# SERVICE No. 991A BULLETIN

DATE: January 29, 1996 (S/M)

**Replacement or Modification of the Alternator Out Light Fuse**

**PA-28-161 (CADET)**  
(Refer to the Maintenance Manual as necessary.)

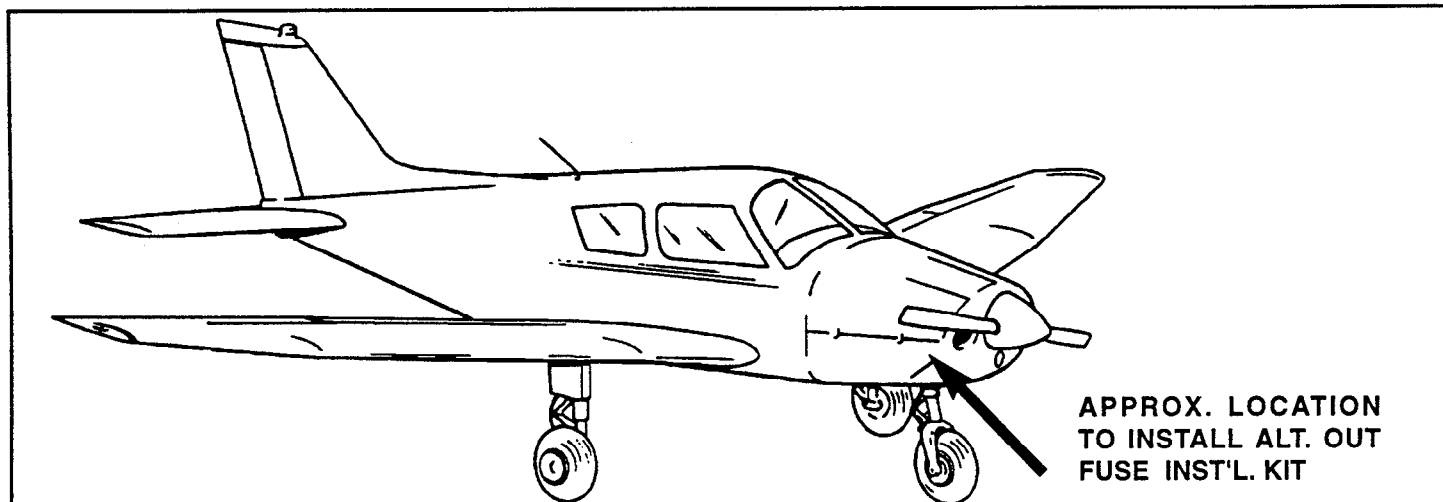
1. Remove the engine cowling.
2. Locate the alternator AUX terminal.
3. Remove the existing wire from the alternator AUX terminal and install the Alt Out Fuse Installation Kit Piper Part Number 766-293 per kit instruction.
4. Secure the fuse holder with a Ty-rap.
5. Perform run up and functional check.
6. Reinstall the engine cowling.

**PA-28R-201 (ARROW)  
PA-28R-201T (TURBO ARROW)**

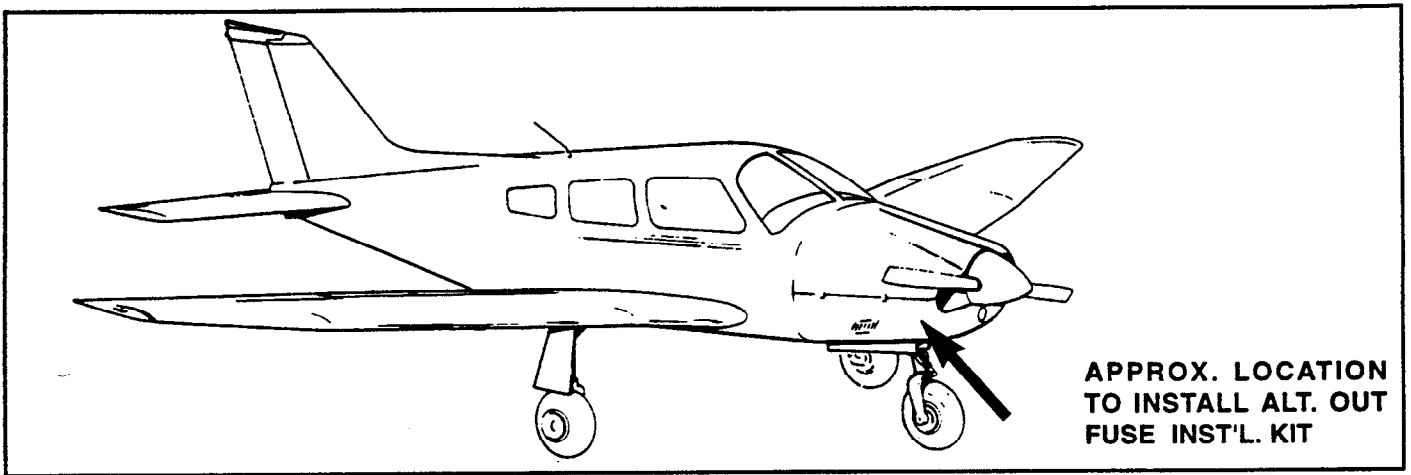
1. Remove the engine cowling. (Arrow shown as typical.)
2. Locate the alternator AUX terminal.
3. Remove the existing wire from the alternator AUX terminal and install the Alt Out Fuse Installation Kit Piper Part Number 766-293 per kit instruction.
4. Secure the fuse holder with a Ty-rap.
5. Perform run up and functional check.
6. Reinstall the engine cowling.

**PA-38-112 (TOMAHAWK)**

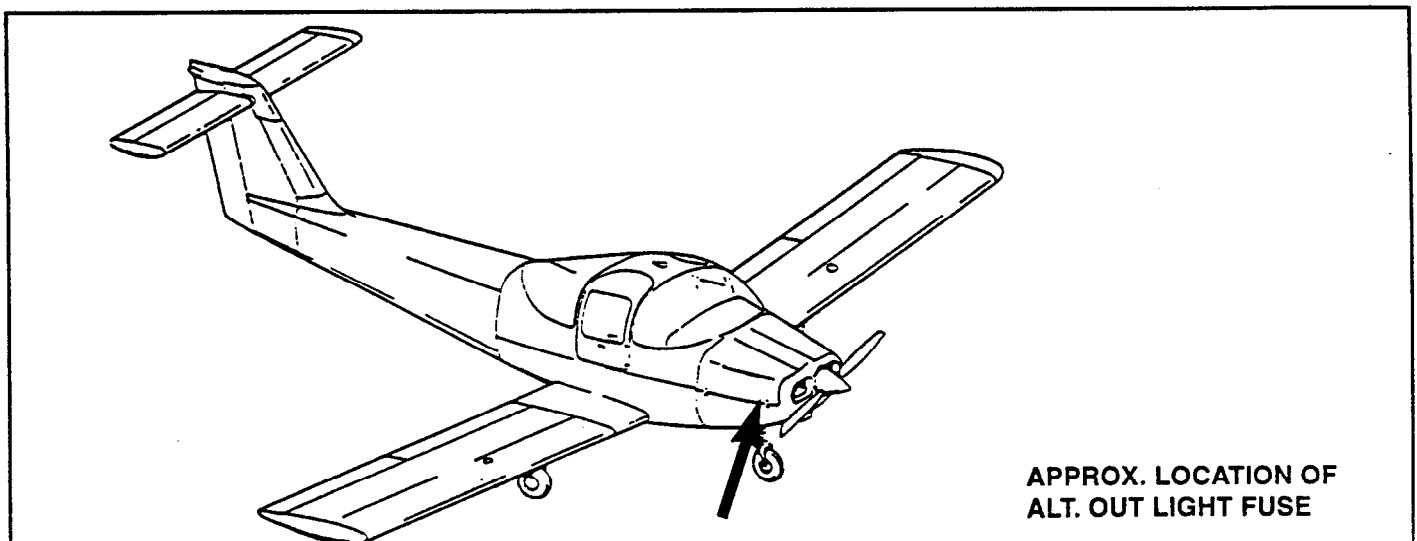
1. Remove the engine cowling to gain access to the alternator.
2. Locate the alternator AUX terminal and follow the wiring to the fuse holder between wire (WIC20) and (WID20).
3. Remove the existing fuse and install new fuse part number 461-643. *NOTE: Inspect condition of the existing fuse holder and replace as required.*
4. Perform run-up and functional check.
5. Reinstall the cowlings.

**PA-31, 31-325 (NAVAJO, NAVAJO C/R)  
PA-31-350 (CHIEFTAIN & T1020)  
PA-31P (PRESSURIZED NAVAJO)**

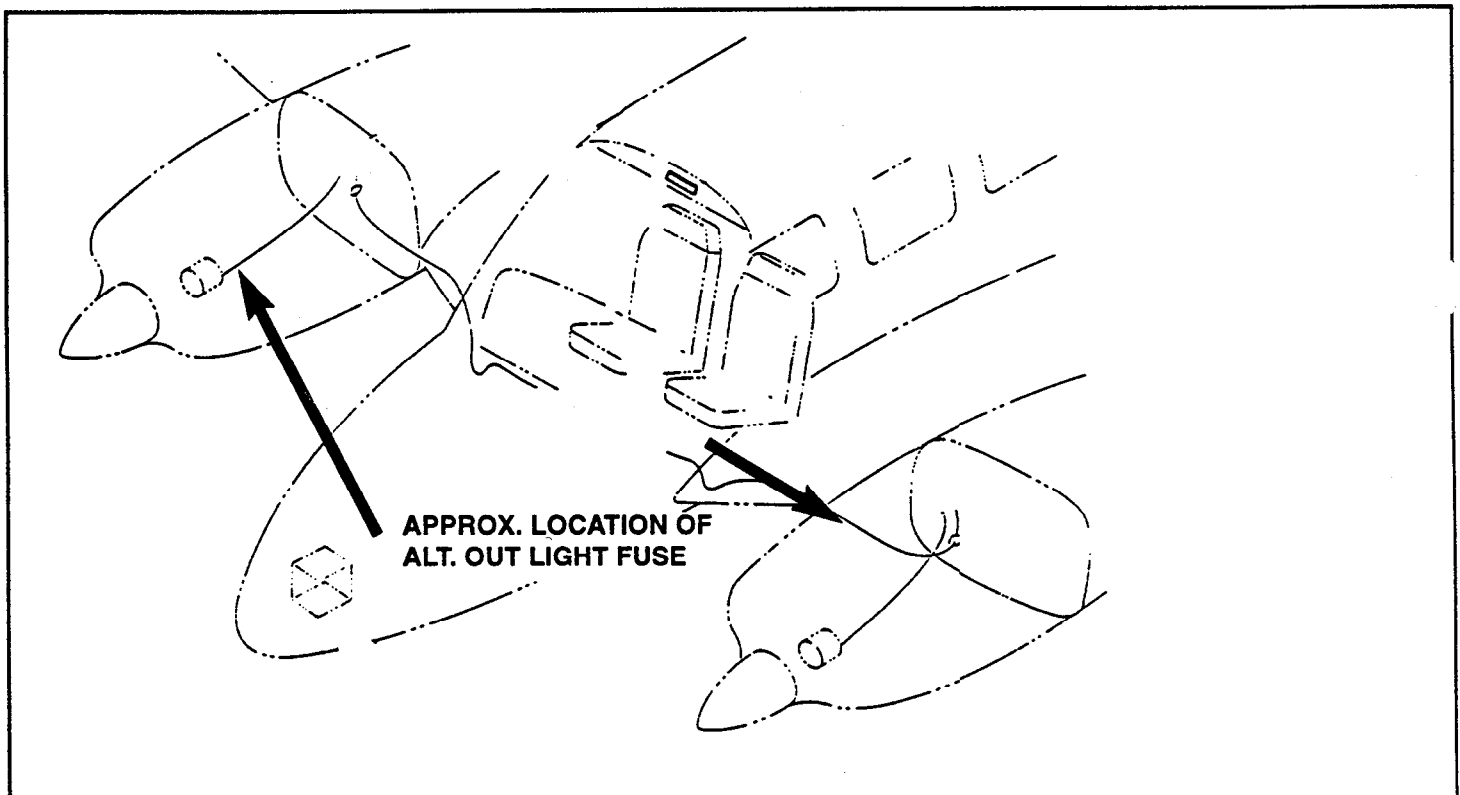
1. Remove the upper and lower engine cowlings to gain access to the alternators.
2. Locate the alternator AUX wire on the left and the right alternator.
3. Follow the wire to the fuse holder.
4. Remove the existing fuse and install fuse part number 461-643, secure wires and fuse holders after installation. *NOTE: Inspect condition of the existing fuse holder and replace as required.*
5. Perform run-up and functional check.
6. Reinstall the cowlings.
